SUBJECT: Pilgrim Nuclear Power Station's Third Six-Month Status Report in Response to March 12, 2012 Commission Order Modifying Licenses with Regard to Reliable Spent Fuel Pool Instrumentation (Order Number EA-12-051)

Pilgrim Nuclear Power Station  
Docket No. 50-293  
License No. DPR-35

LETTER NUMBER 2.14.062

**PILGRIM NUCLEAR POWER STATION'S  
THIRD SIX-MONTH STATUS REPORT IN RESPONSE  
TO MARCH 12, 2012 COMMISSION ORDER MODIFYING  
LICENSES WITH REGARD TO  
RELIABLE SPENT FUEL POOL INSTRUMENTATION  
(ORDER NUMBER EA-12-051)**

Figure 1: SFP Plan View

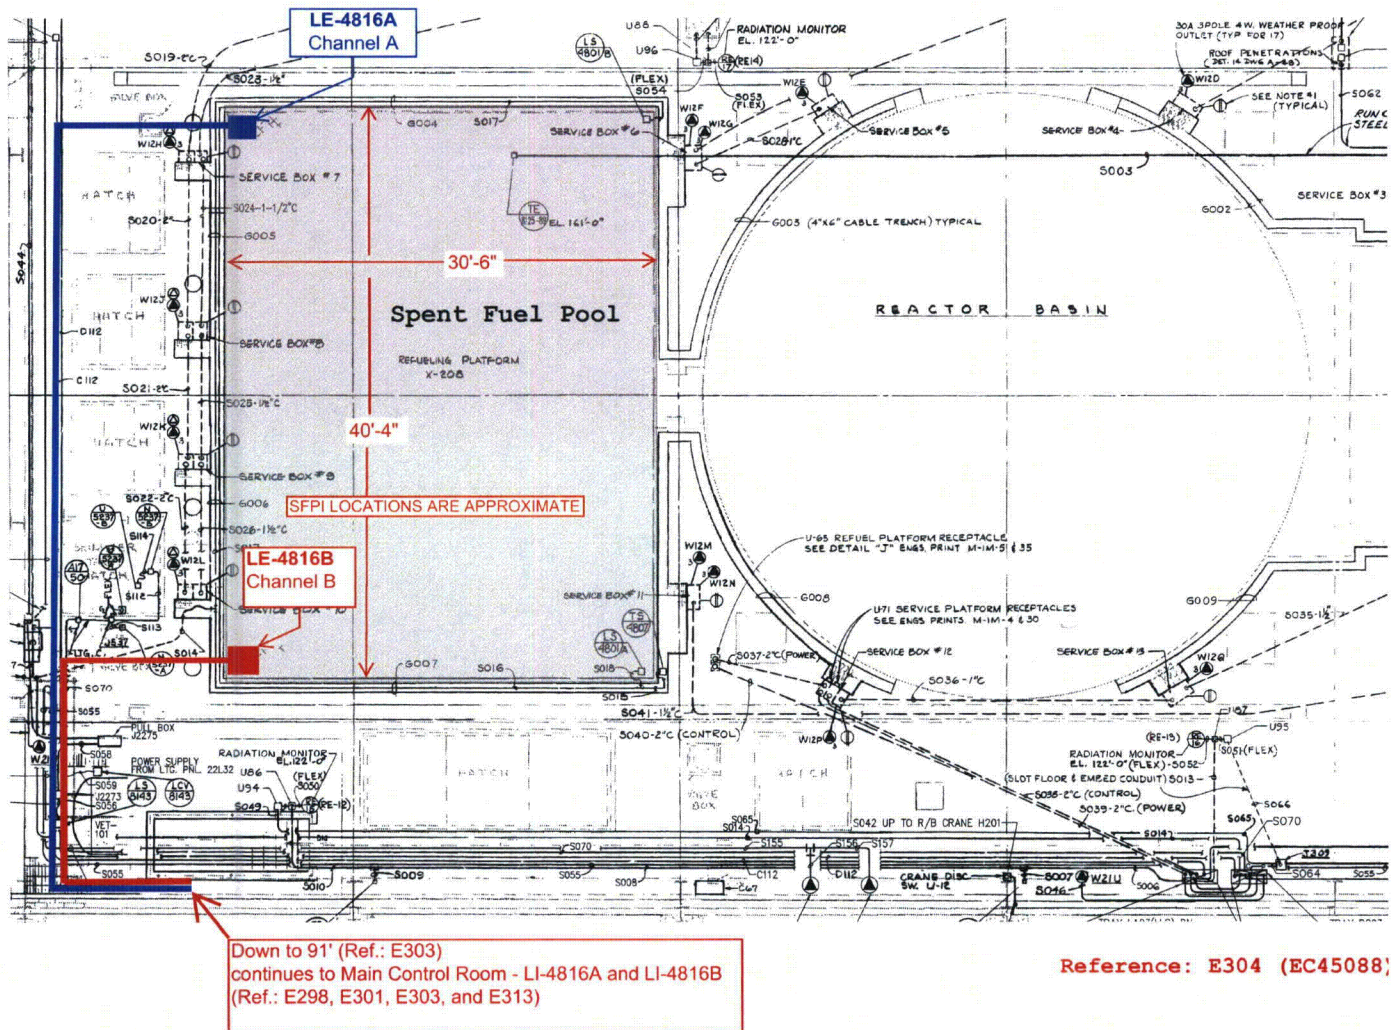
**Please provide a clearly labeled sketch or marked-up plant drawing of the plan view of the SFP area, depicting the SFP inside dimensions, the planned locations/placement of the primary and back-up SFP level sensor, and the proposed routing of the cables that will extend from these sensors toward the location of the read-out/display device.**

In Section 3.4 of the Interim Staff Evaluation (ISE), NRC staff stated that they have concerns with the proximity of the routing from the instrument probe to the instrument display location and whether this arrangement is in accordance with the guidance on channel separation, as described in NEI 12-02. The SFPI conduit is routed to exit the Refuel Floor, elevation 117 ft as soon as possible to minimize the possibility of physical damage to both loops from damage due to potential debris during a beyond design basis external event. The Channel A conduit will be installed on or very close to the floor at the west wall until it exits the refueling floor. The Channel B conduit will be installed at a higher elevation above the refueling floor in the southeast corner until it exits the refueling floor.

Figure 1 shows the approximate locations of the SFPI probes, the inside dimensions of the SFP, and the proposed cable routing.

**Figure 2: SFPI Power Supply Diagram**

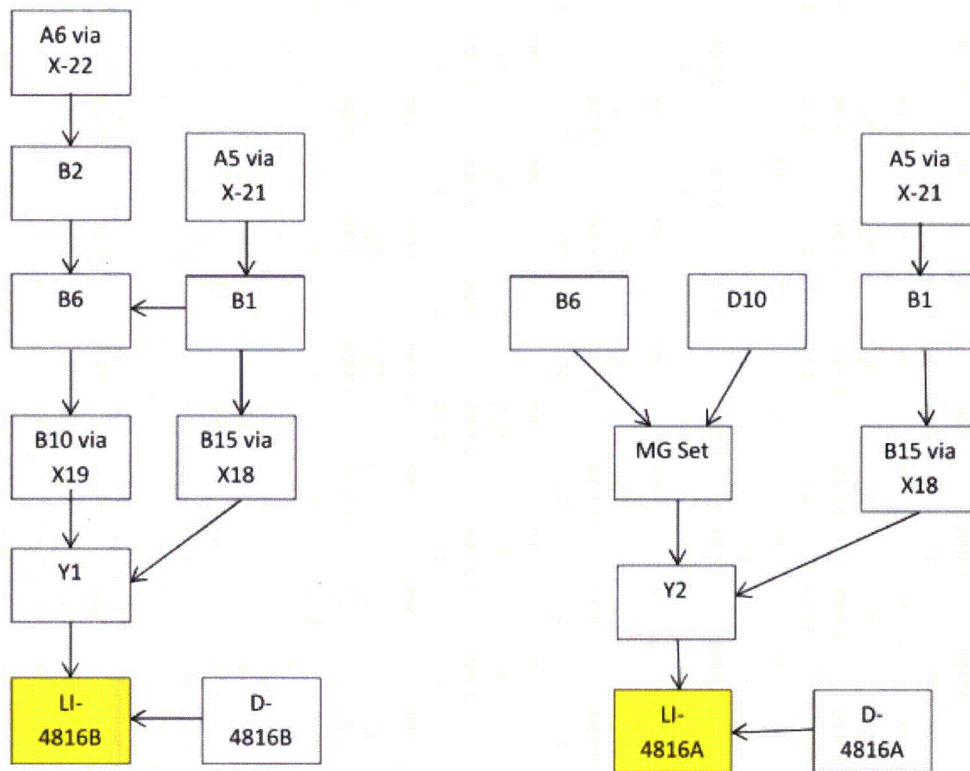
**Please provide the NRC staff with the final configuration of the power supply source for each channel so that the staff may conclude that the two channels are independent from a power supply assignment perspective.**

Channel A will normally be powered from Y2 Breaker 1. Panel Y2 can be energized from either of two sources. The normal or preferred supply is the Vital MG set. Normally the motor-generator (MG) set is driven by the 480V AC motor. Upon loss of power center B6 or in the event that the 480V feeder Breaker 52-606 trips, the MG is automatically maintained in rotation by the backup 250V DC motor. The alternate or emergency source consists of 480V power center Breaker 52-1514 with its associated transformer X18. B15 is powered from A5 via B1.

Channel B will normally be powered from Y1 Breaker 1. Panel Y1 can be energized from either of two sources. The normal or preferred source is via transformer X19 and 480V breaker 52-1015 on power center B10. B10 is powered from A5 via B1 and B6 or from A6 via B2 and B6. Should the normal supply fail, Panel Y1 is transferred to the alternate source which is via transformer X18 and 480V breaker 52-1514 on power center B15. B15 is powered from A5 via B1. Figure 2 shows a simplified diagram that demonstrates the independence of the power supplies.
